**DOCUMENT 00 90 00  
ADDENDUM**

**ADDENDUM NO. [1]                      Date: March 13, 2020**

**RE:                      SCHOOL DISTRICT OF HOLMEN  
                             HIGH SCHOOL ADDITION AND REMODELING PHASE 2  
                             1001 McHUGH ROAD  
                             HOLMEN, WISCONSIN 54636  
                             HSR 18061**

# 1 AHU-2 & 3 CONTROL SCHEMATIC

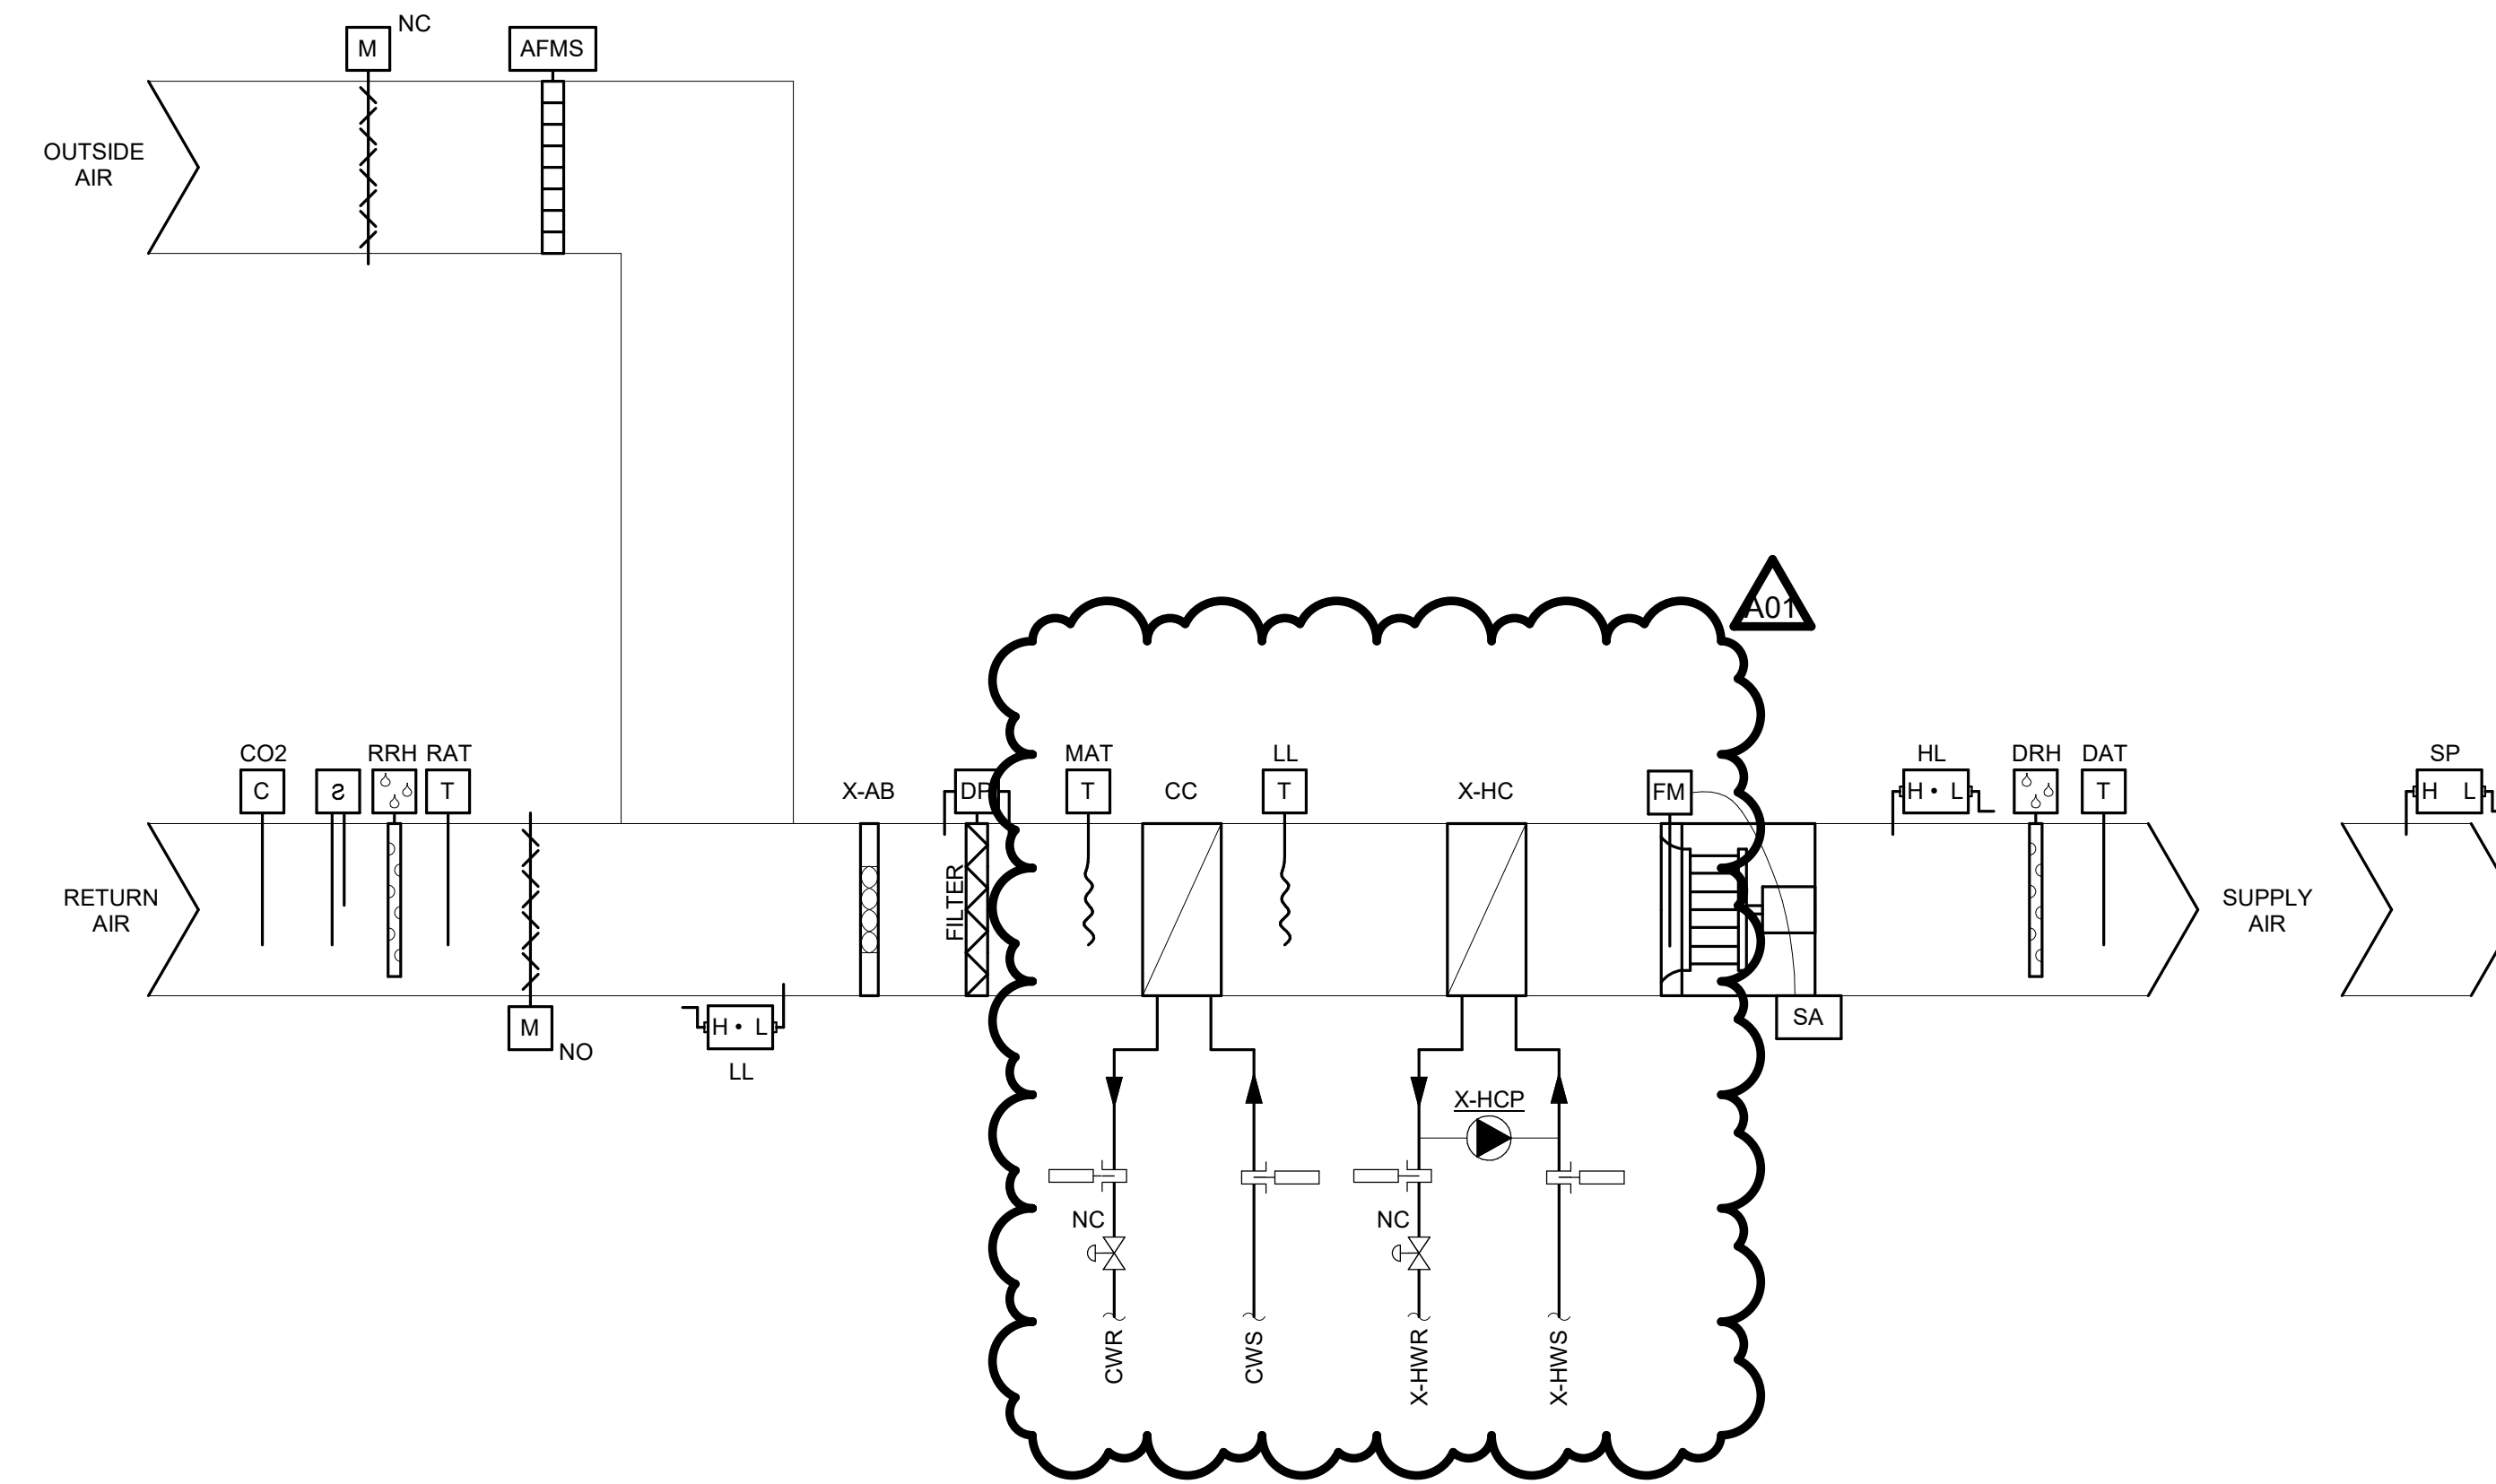
- a. Revisions clouded on Drawing.
  - b. Revised controls for new Air Handling Units (AHU-2 and AHU-3).
35. Sheet M401 AHU-2 DETAILS 30 x 42 attached hereto.

M402

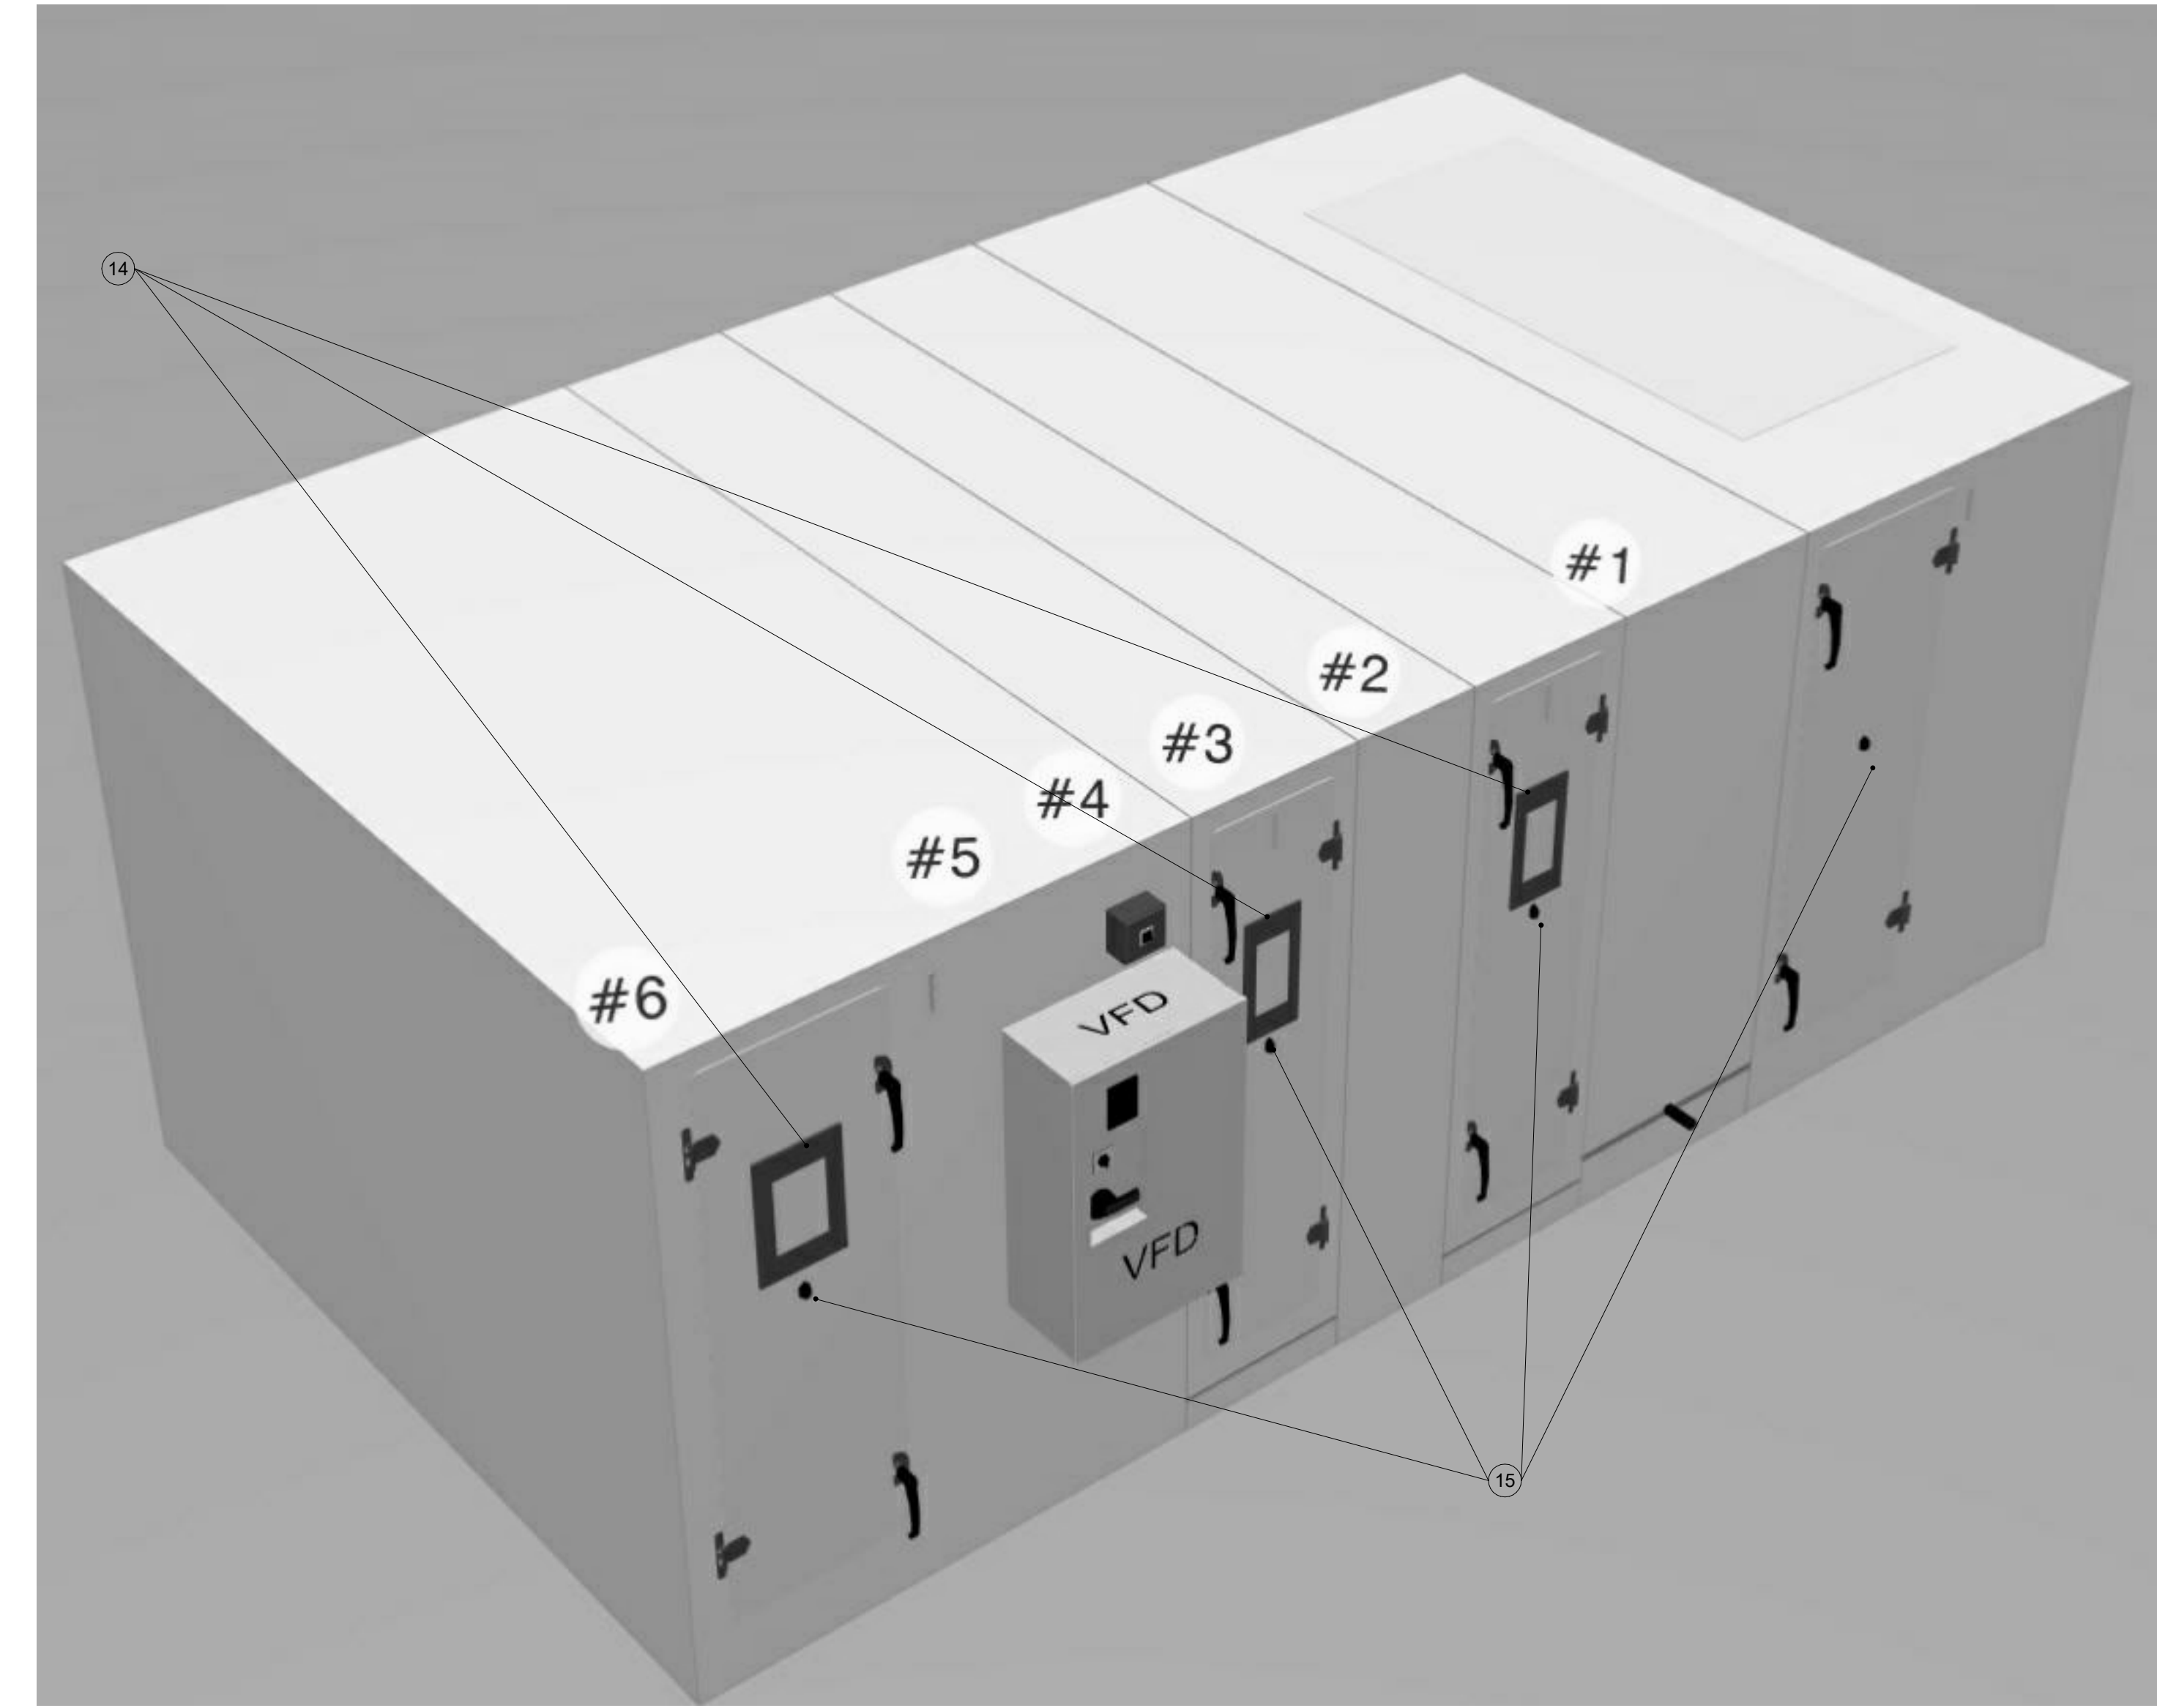
- a. Drawing attached hereto shall be included in contract documents.
  - b. Indicating details for new AHU-3.
37. Sheet M501 HVAC DETAILS 30 x 42 attached hereto.
